TIL # 298R1

**LOW FLOOR BATTERY DISCONNECT
MODIFICATION**

Models Affected: NFI LOW FLOOR 7101-7191 **Locations Affected:** ALL

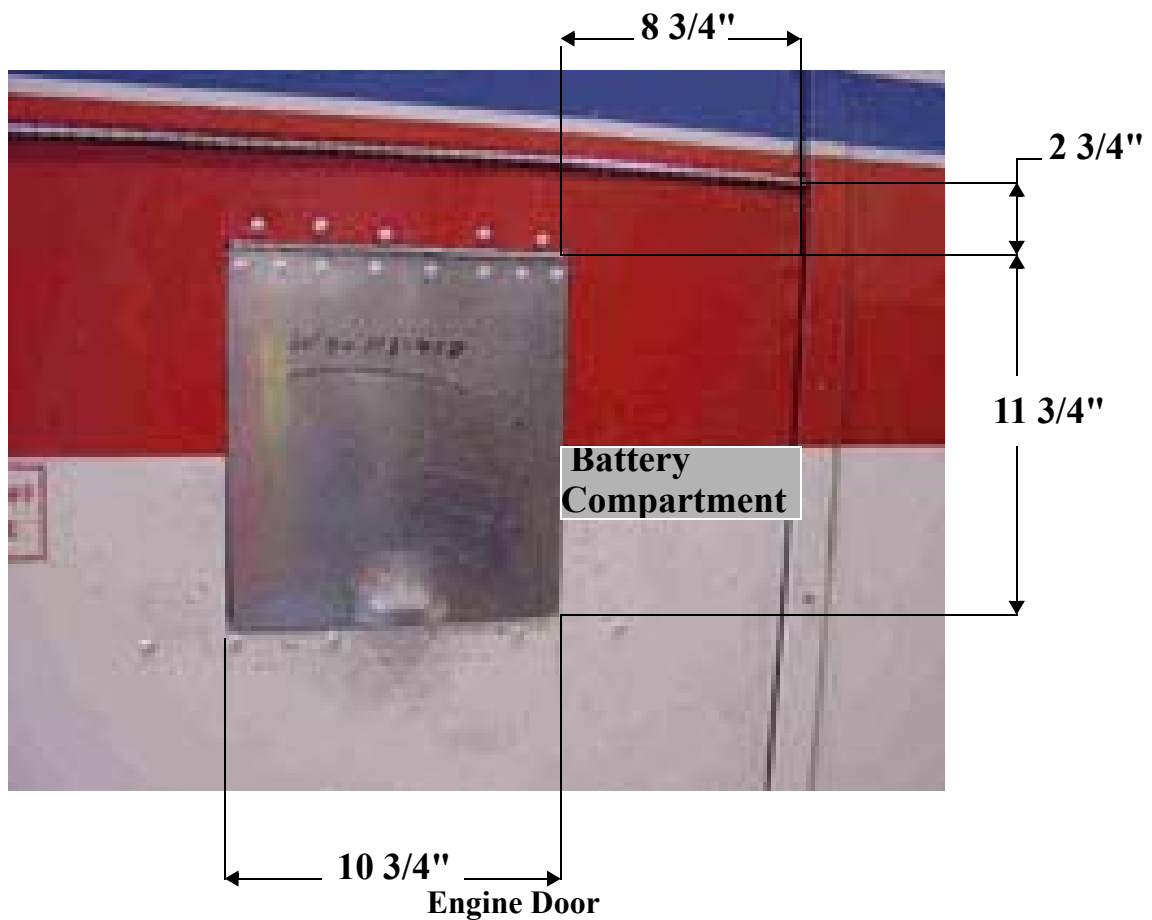
Cut hole in engine door as shown in picture below.

Door Assembly

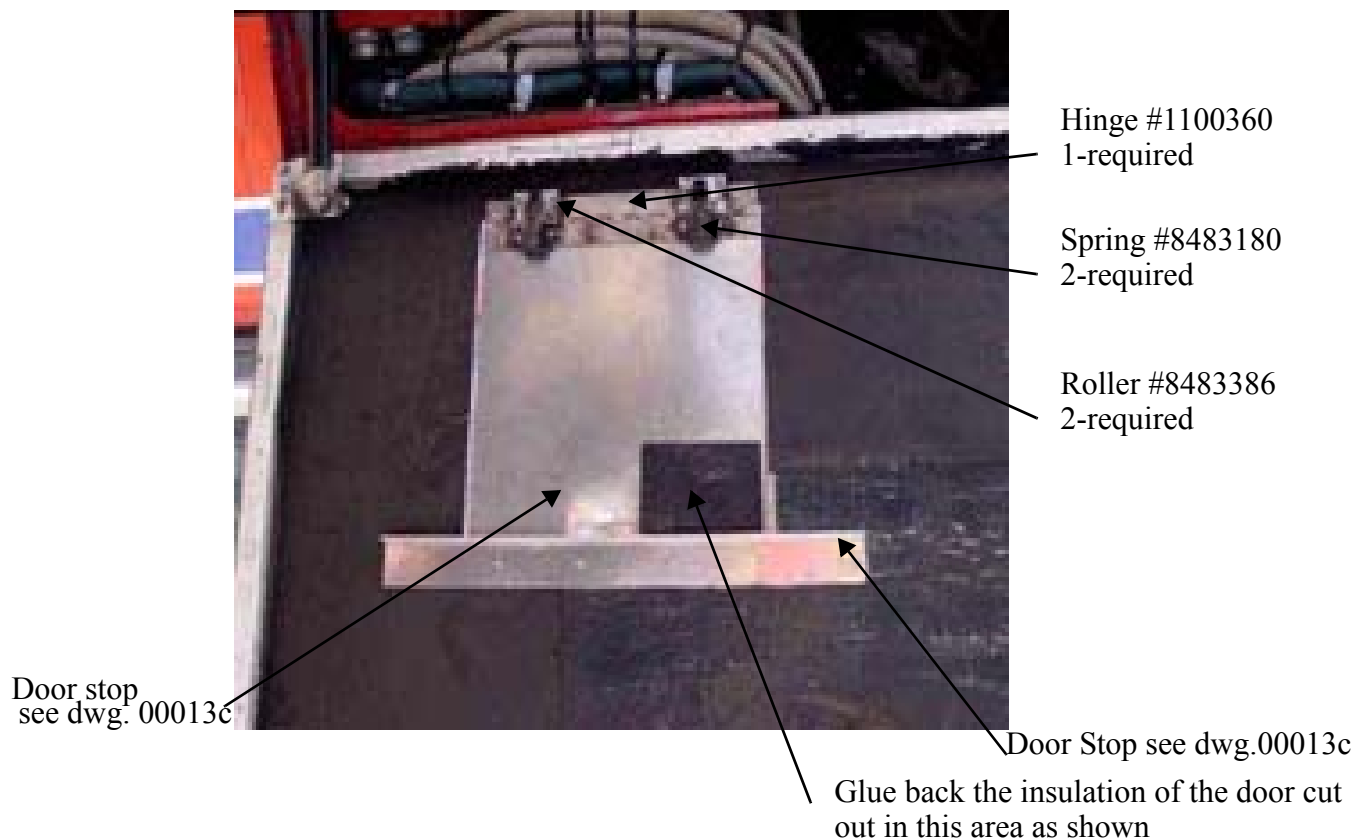
10. Install door assembly using "buck" rivets.

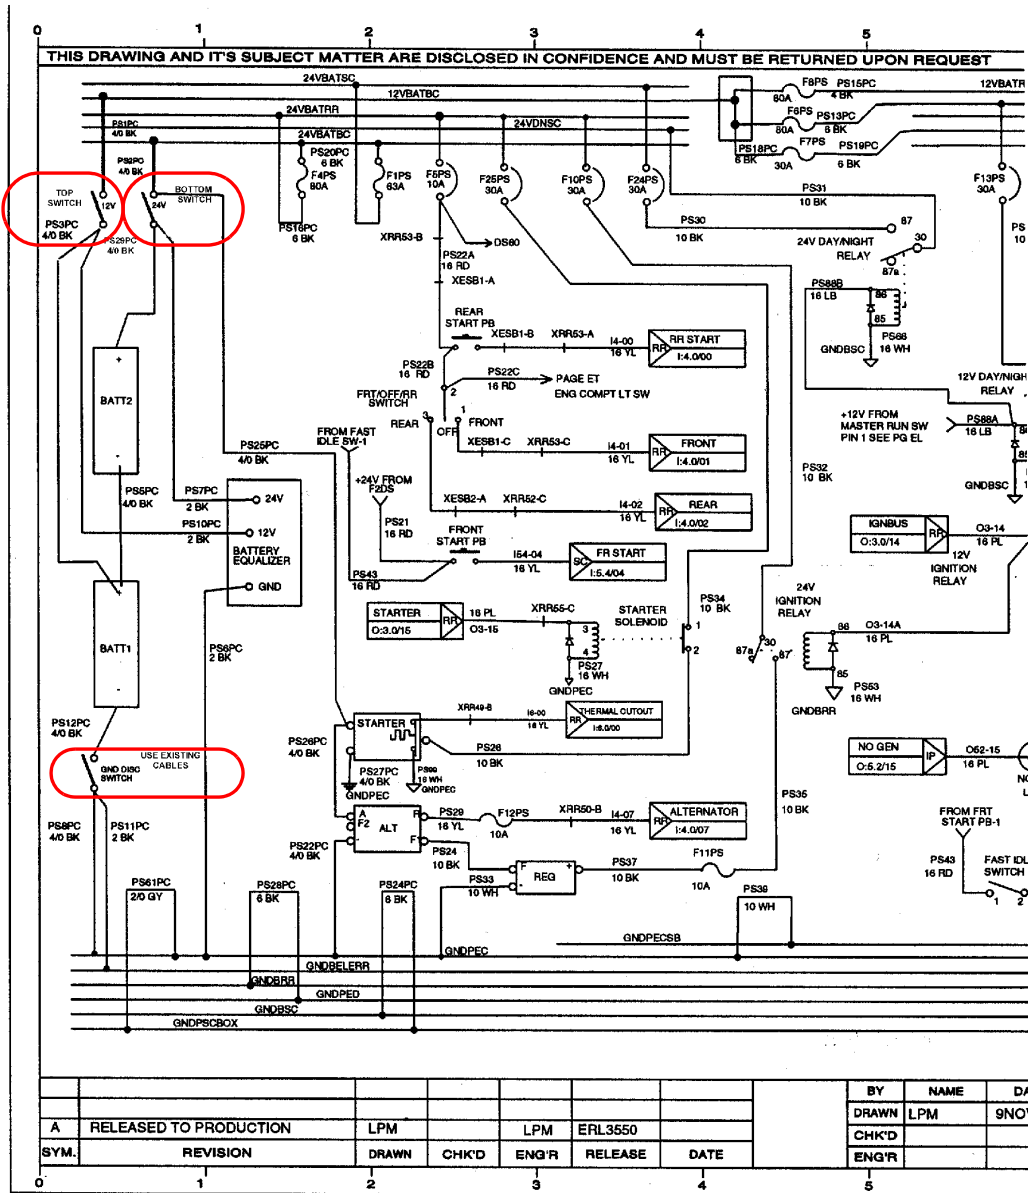
1. Remove old battery switches and brackets.
2. Install battery switch mounting plate by drilling and tapping 4 1/2" x 5/16" N.C. bolts. Reference picture on page 1. Approximately 8" from forward bulkhead. Also use 2 5/16" x 1" sleeves in order not to crush the 1" thick insulation.
3. Check old switches for re-use and install on battery switch mounting plate. If needing replacement, replace with double switch (part #9478670) and single switch (part #9478682).
4. Remove 4/0 cable "PS2PC" from 24V bus bar.
5. Remove 4/0 cable "PS1PC" from 12V bus bar in rear box.
6. Install new cable through water tight fittings in bottom of box. (+- 96" length each). Install (crimp & solder) 5/16 x 4/0 terminal in box end of cable. Install 1/2" x 4/0 terminal at switch end of cable.
7. Refer to diagram on page 5 of this T.I.L. for correct cable hook at switches.
